Town of Los Gatos Planning Commission

Re: Comments and objection regarding the proposed second-story addition at 16717 Chirco Drive (APN 424-20-014), Minor Residential Application MR-24-018 — from the adjacent property owner at [REDACTED]

Figure 1: Windows facing [REDACTED] Backyard, providing direct sight into the backyard and pool.

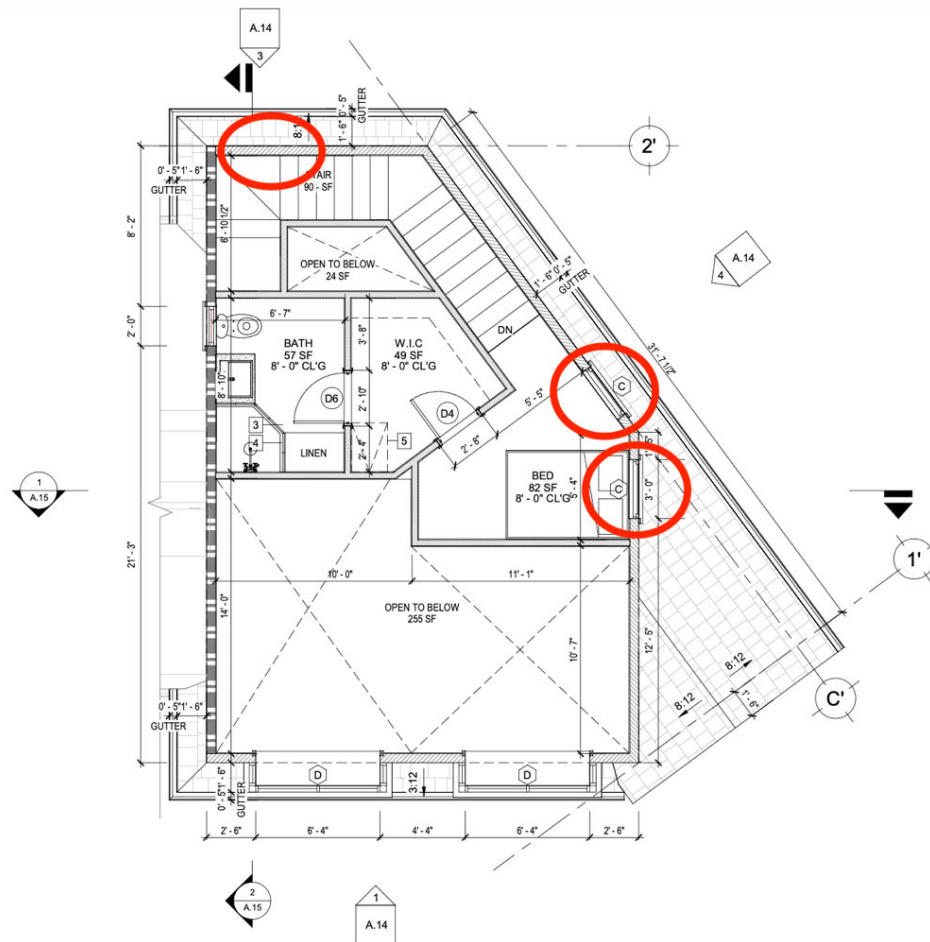
A. Privacy: The proposed second story includes two windows on the east and southeast and one window on the north elevations. These windows provide a direct line of sight into our backyard and swimming pool. Given that our family frequently utilizes the pool and backyard, these windows raise significant privacy concerns. (Figure 1)

Figure 2: Findings by Cannon Design Group.

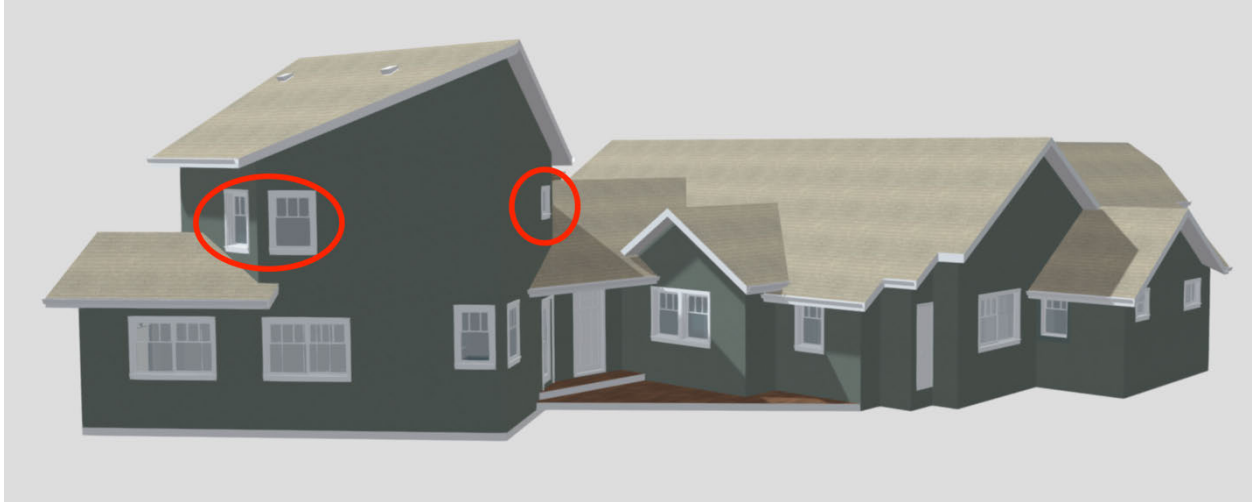
The proposed garage and second floor bedroom addition are not consistent with several Residential Design Guidelines.

1. The addition is very awkward and not consistent with the Residential Design Guideline 3.1 Principles.

Figure 4: Proposal to construct the living area in A and eliminate the side windows and area B.

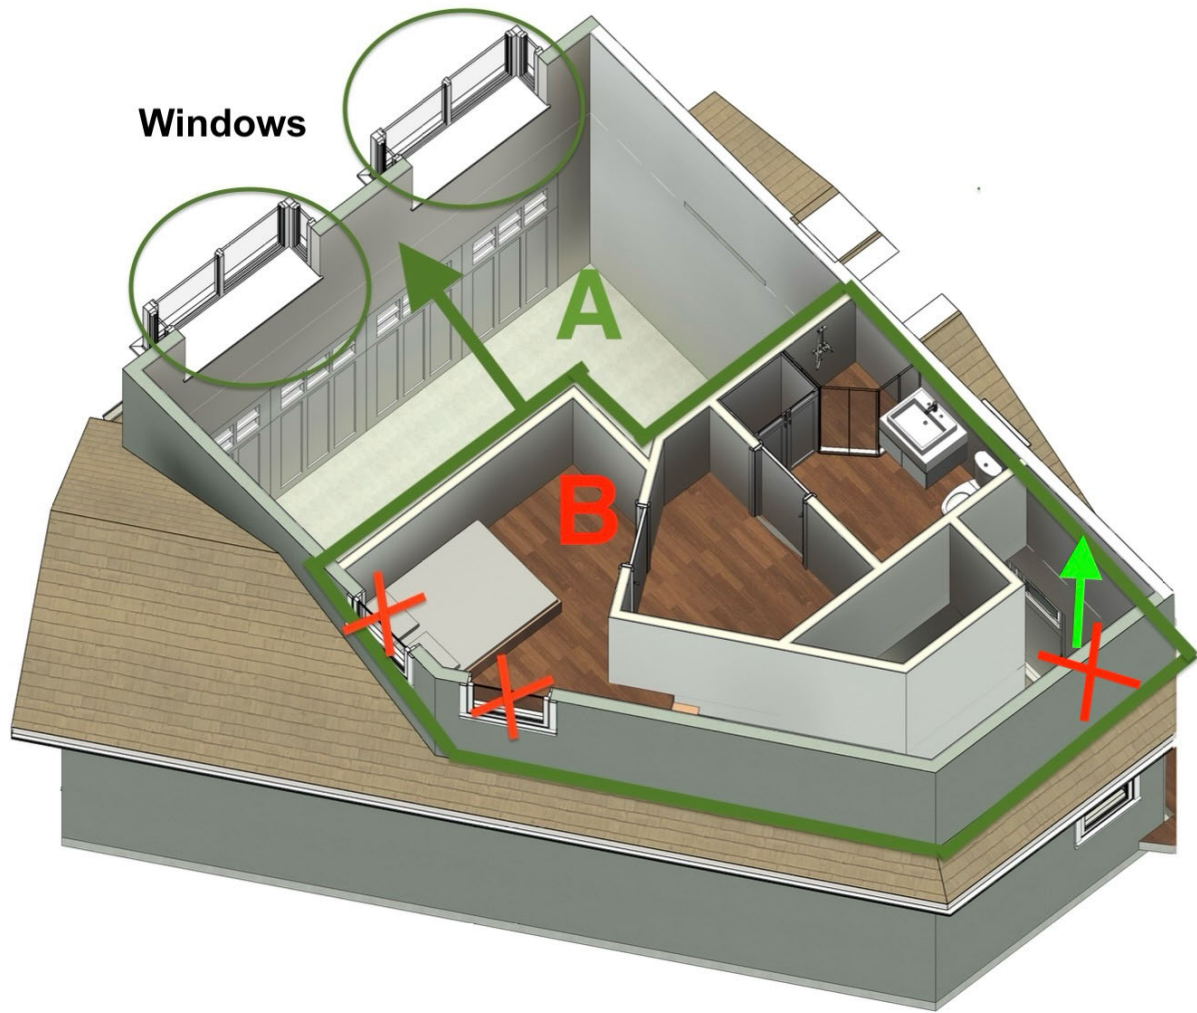
D. Suggestion #1 to reduce mass and address privacy concerns: To address both mass and privacy impacts, we identified an open area (area A in Figure 4) adjacent to the living area on the second floor (area B in Figure 4). The living area B could be constructed within area A, adjacent to the street-facing windows, thereby utilizing the street-facing windows and eliminating the necessity of having two windows facing our backyard (marked with red crosses in Figure 4). The third window can be eliminated by constructing a window on the west-facing wall (indicated by the green arrow in Figure 4). These modifications would address privacy concerns by eliminating the unwanted windows, while simultaneously reducing mass by eliminating the unoccupied area (area B).

Figure 5: Proposal to construct the second story unit adjacent to the existing house.

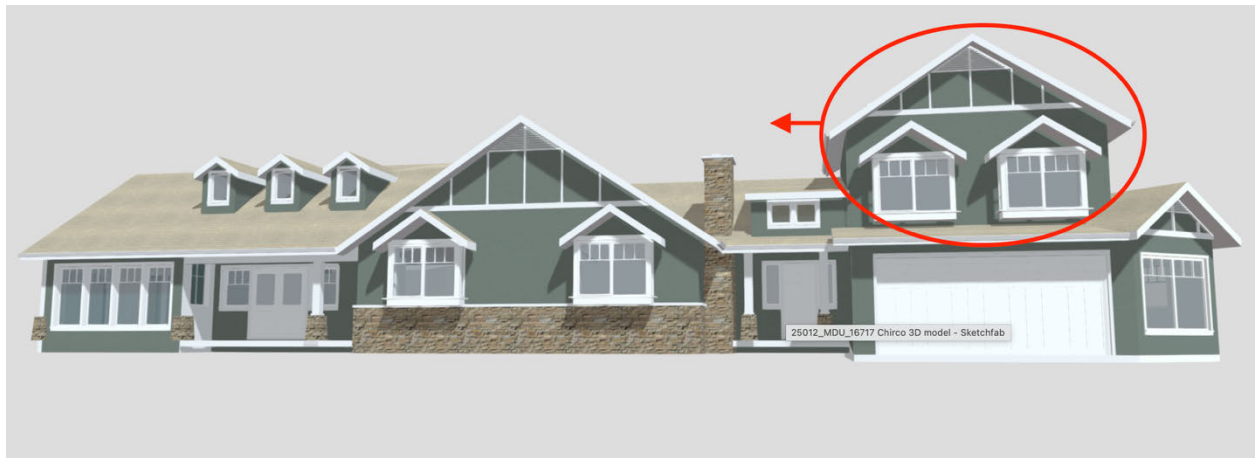
E. Suggestion #2: Another suggestion to address mass and privacy concerns is to construct the second story closer to the main house (Figure 5). For this option to be effective, it should be combined with relocating area B to area A, eliminating the side windows, and removing the additional space. This comprehensive approach would effectively address both the excessive mass and privacy issues.

Figure 6: Design modifications to address mass, height and privacy concerns.

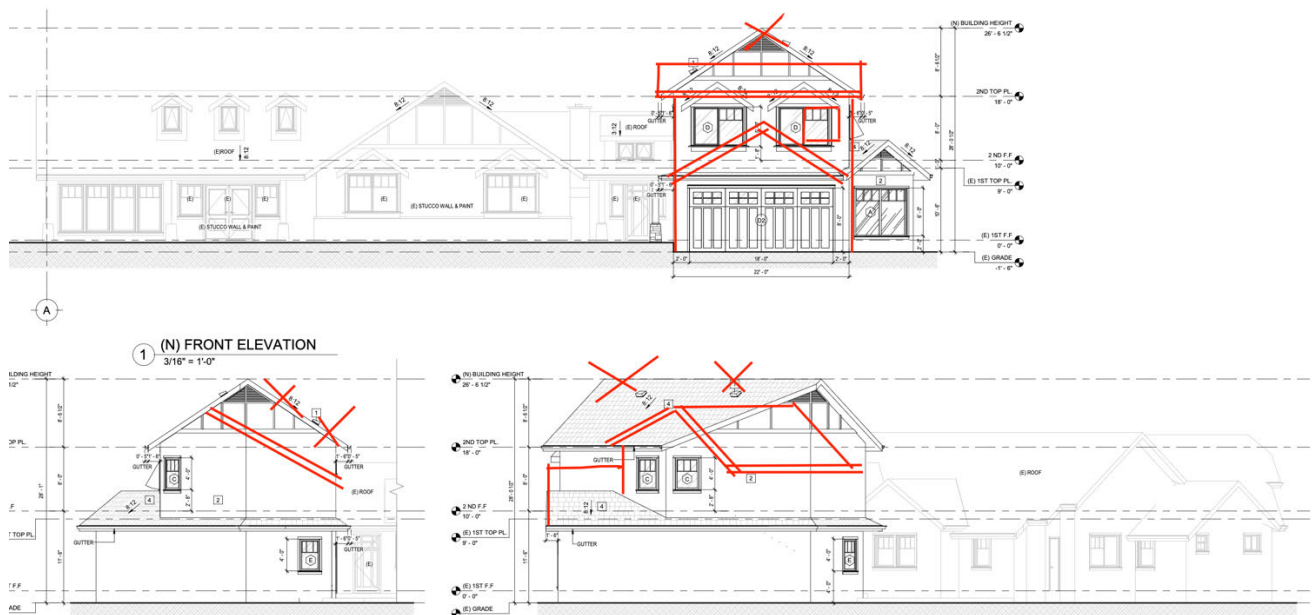
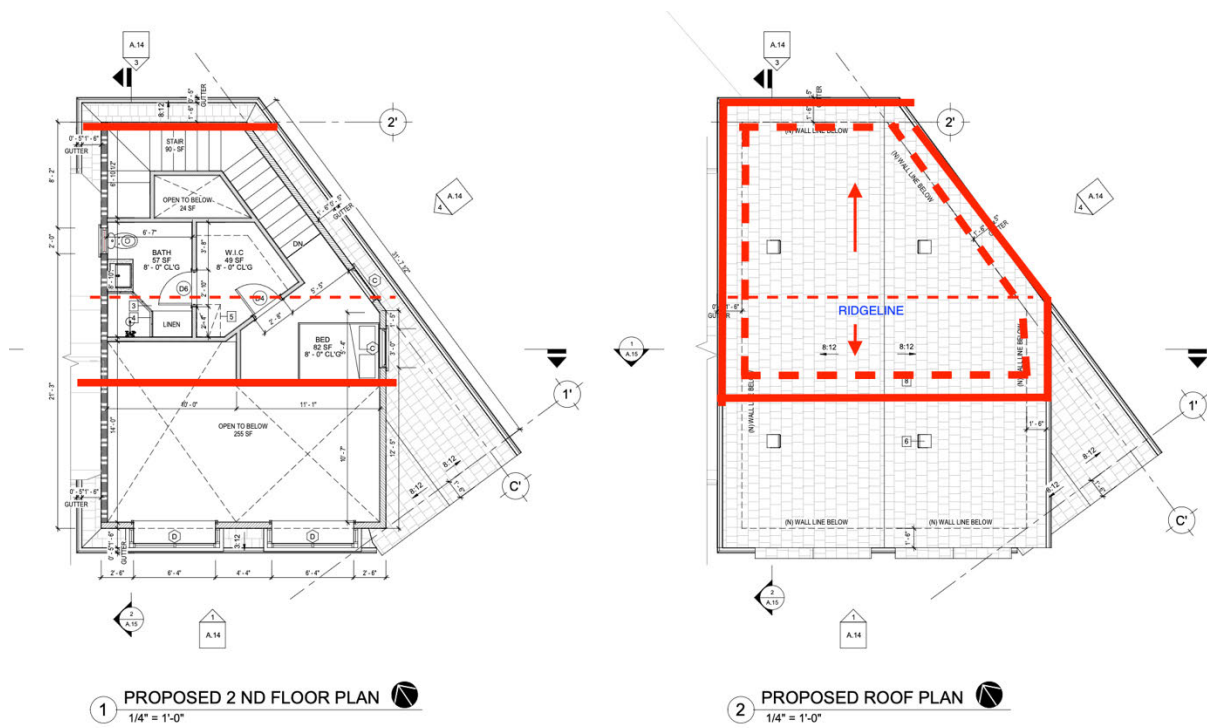
F. Suggestion #3: Figure 6 presents additional modifications that address our concerns without reducing the square footage. Please note that, all the above-mentioned suggestions are merely preliminary proposals to demonstrate that our concerns can be addressed with reasonable
